Index 521-511

Concrete Barrier/Noise Wall (14'-0")

COMMENTS AND RESPONSES

FRONT FACE ELEVATION

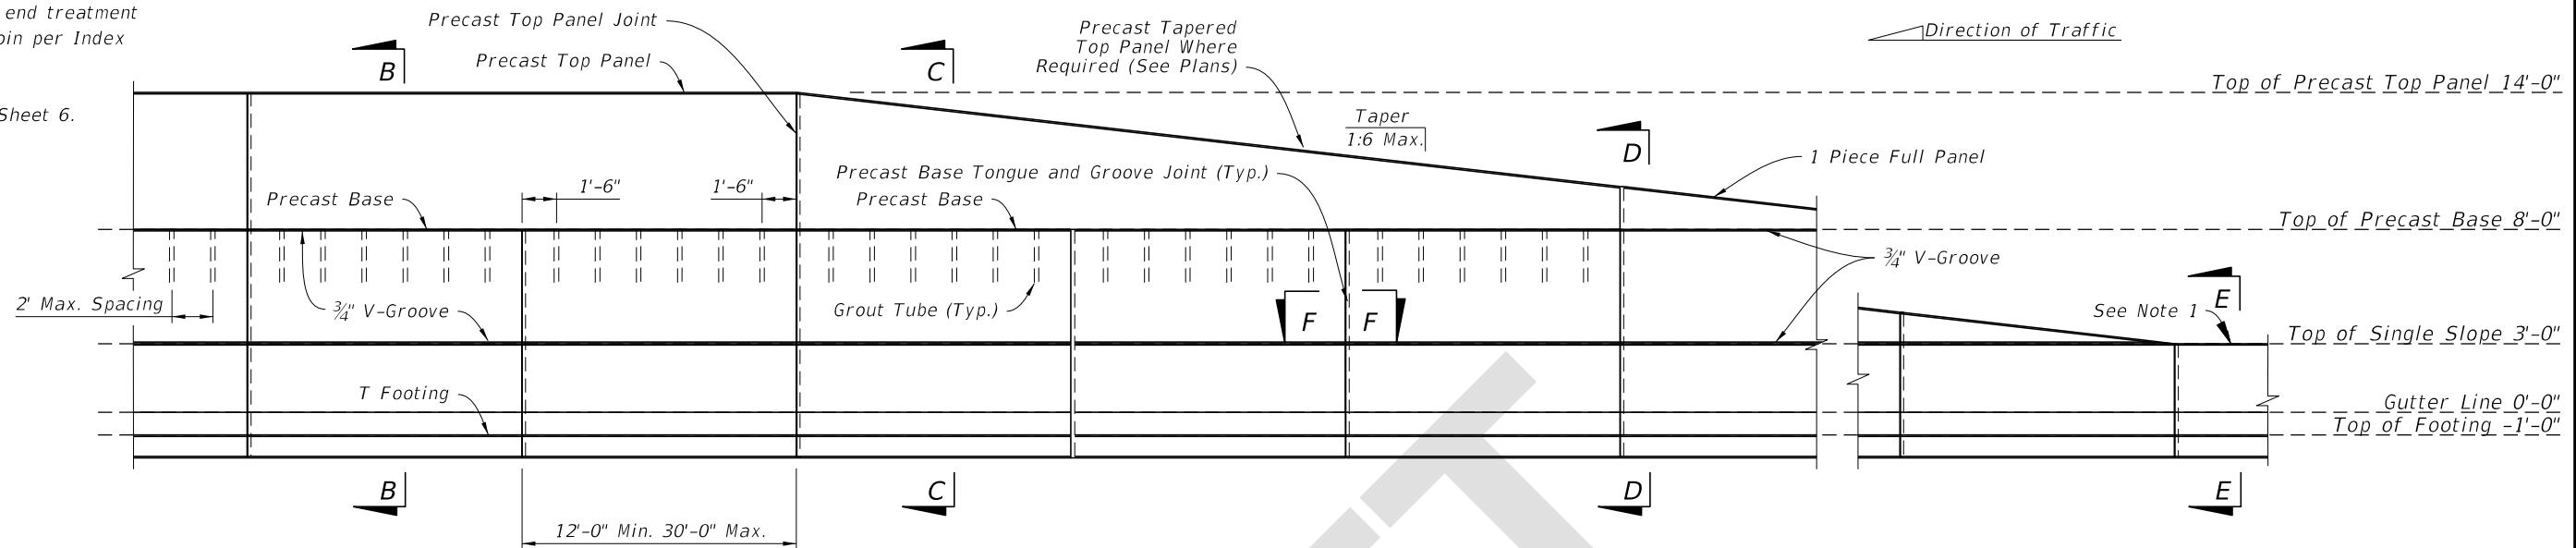
COMMENT: Tapered section for the precast options (Indexes 521-510 and 521-511) have labels stating "Field Cut Bars as Required for Taper". If the tapered sections are to be precast, then the bars cannot be "field cut". Either show that the tapered sections are cast-in-place or change the note to "See Roadway Plans for Taper Length" (or similar). Also, the detail of the reinforcement in the Front Face Elevation View should show top longitudinal bar to be parallel to the taper of the wall.

Index 521-511 (Sheet 5 of 6): Section D-D should show a grout tube and Bar 9C1. Also, tapered section below Top of Precast Base (8'-0"), should have additional information (sections, labels, etc.). That tapered section resembles Index 521-510.

RESPONSE: Agree with these comments. We will update both Indexes to accommodate.

CHANGE MADE TO INDEX: Yes.
